**ADDENDUM 2 TO BID DOCUMENTS FOR THE  
CAMINADA HEADLAND BACK BARRIER MARSH CREATION PROJECT  
(BA-0171)**

**LAFOURCHE AND JEFFERSON PARISHES, LOUISIANA**

**STATE OF LOUISIANA  
COASTAL PROTECTION AND RESTORATION AUTHORITY**

**December 20, 2019**

INSTRUMENTED SETTLEMENT  
PLATE AND CONSTRUCTION  
SURVEY LAYOUT  
 DESIGNED BY: AMANDA TAYLOR, P.E.  
 APPROVED BY: SHANNON HAYNES, P.E.

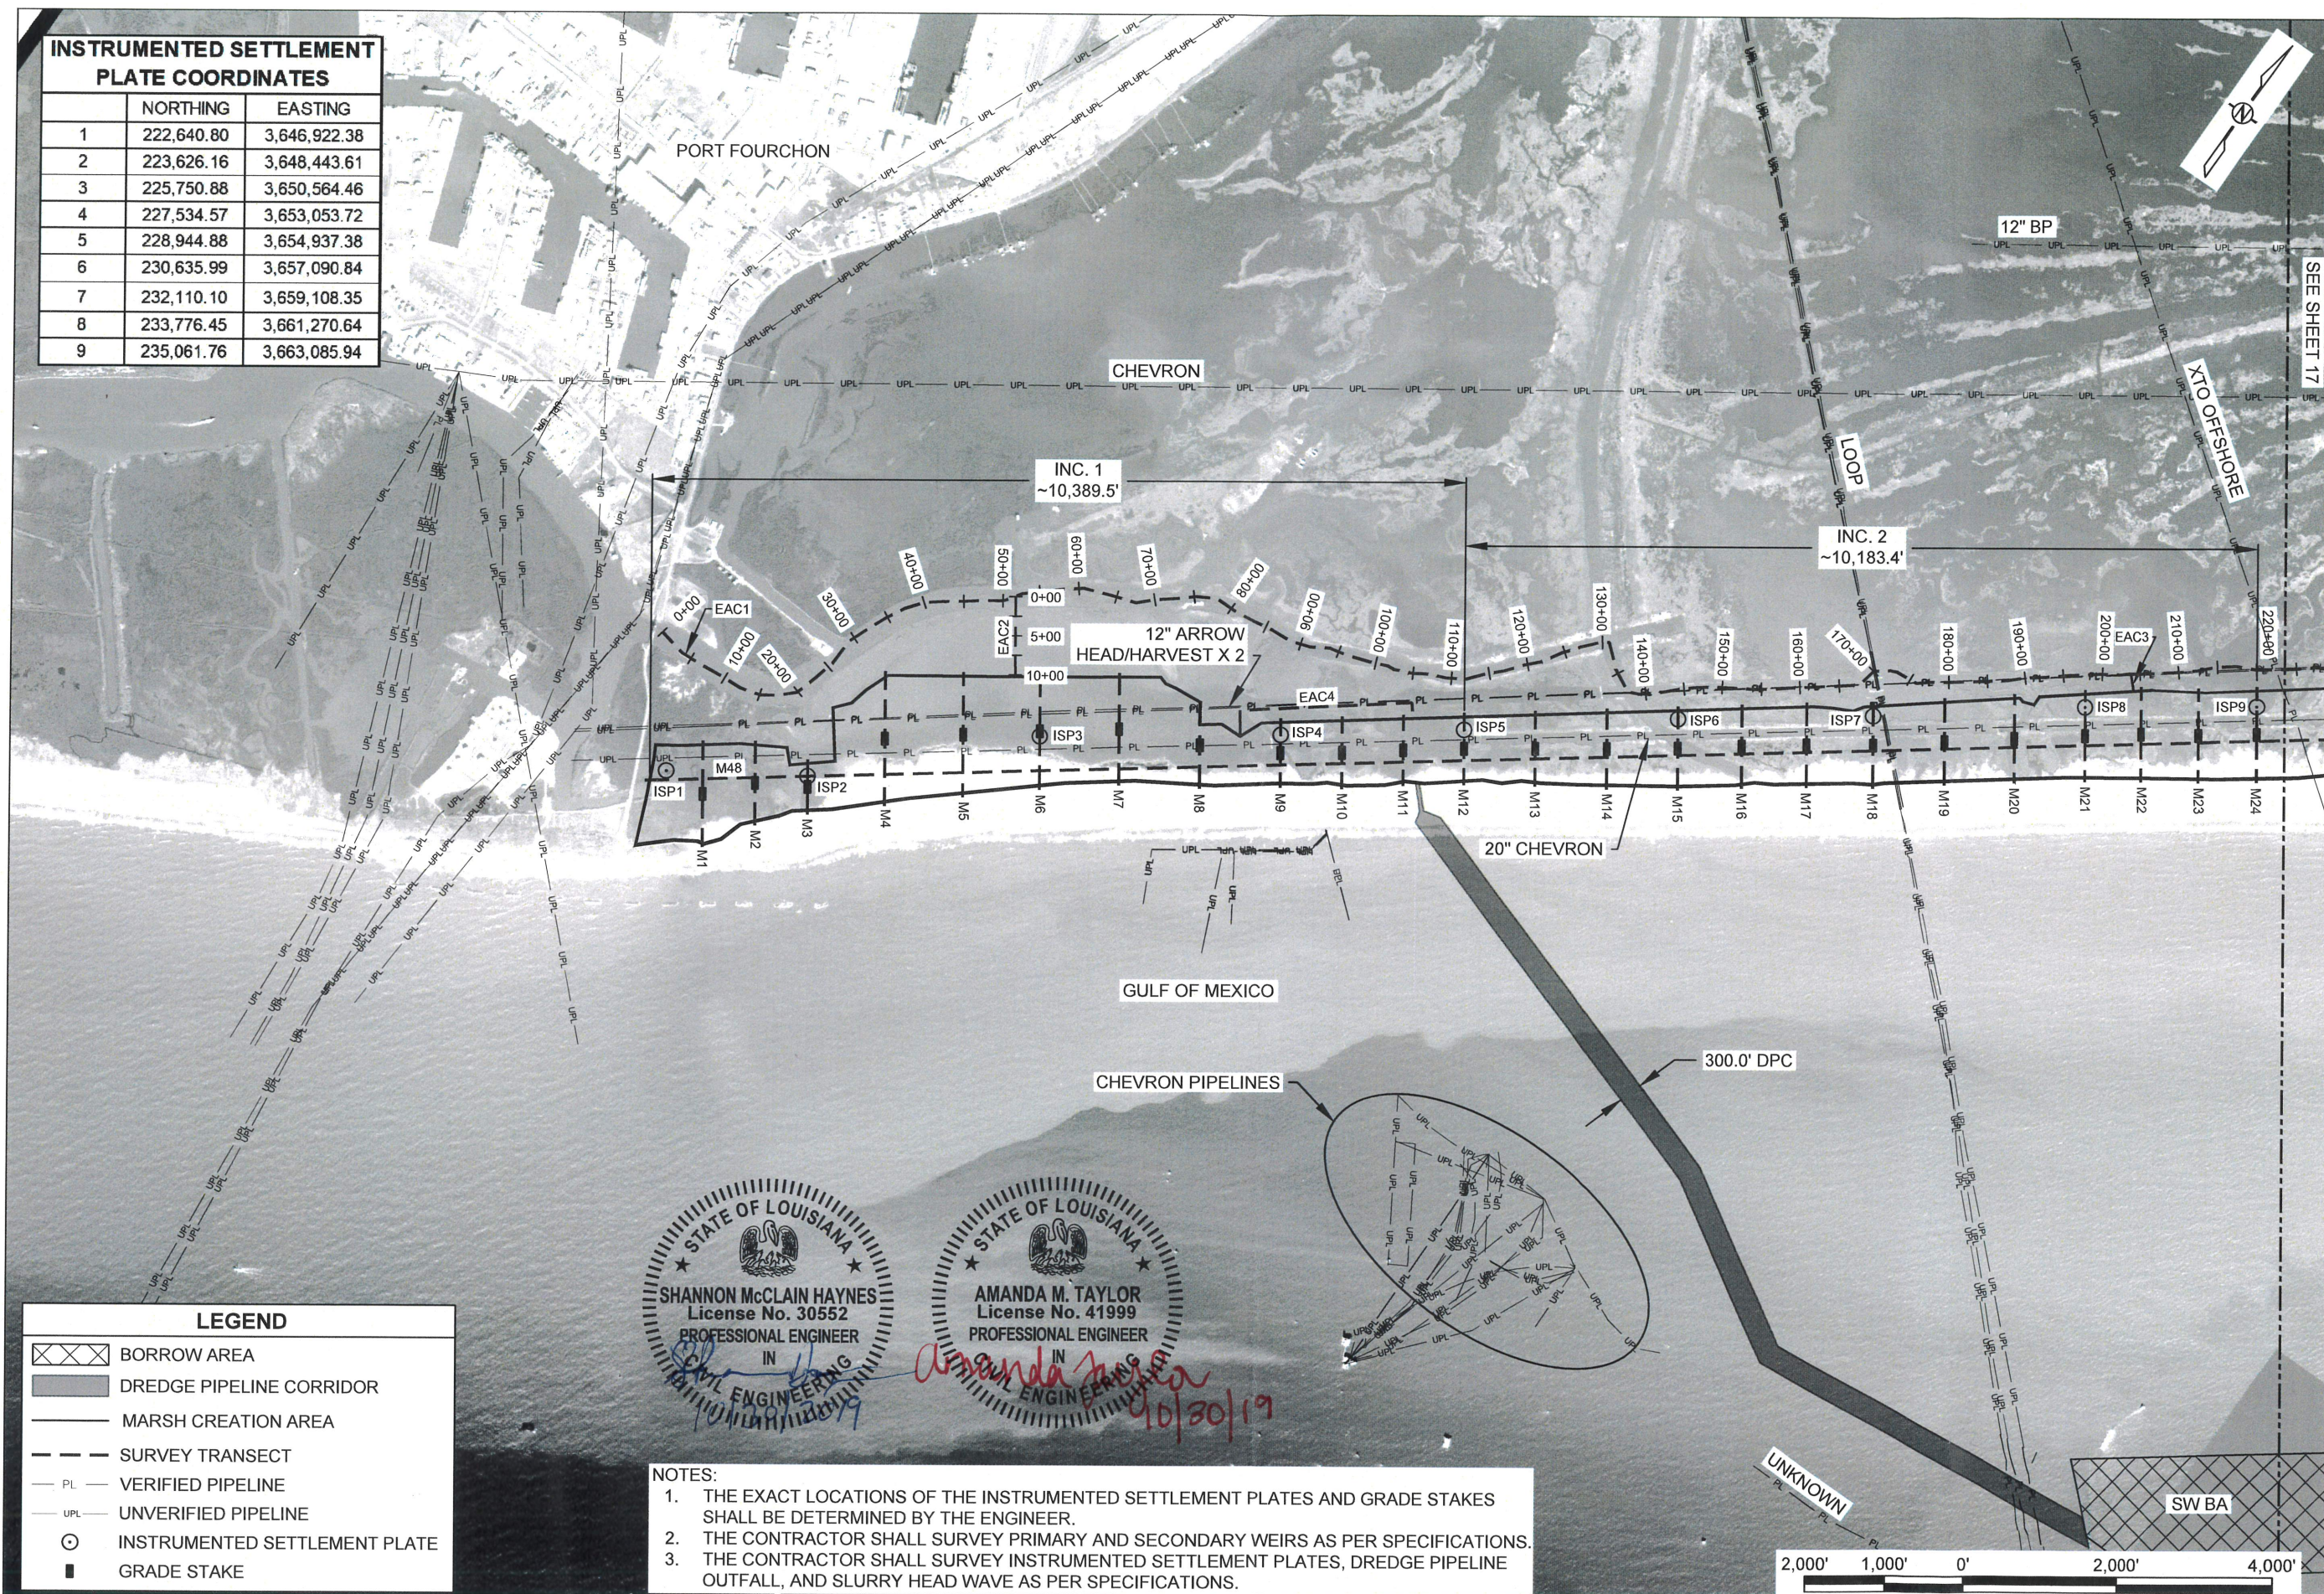
6. **Question:** Will the engineer revise DWG Sheet 16 of 53 in higher quality? This drawing shows the instrument settlement plate and construction survey layouts?

**Response:** Sheet 16 of the Plans is provided with better resolution in this Addendum. No modifications have been made to this sheet.
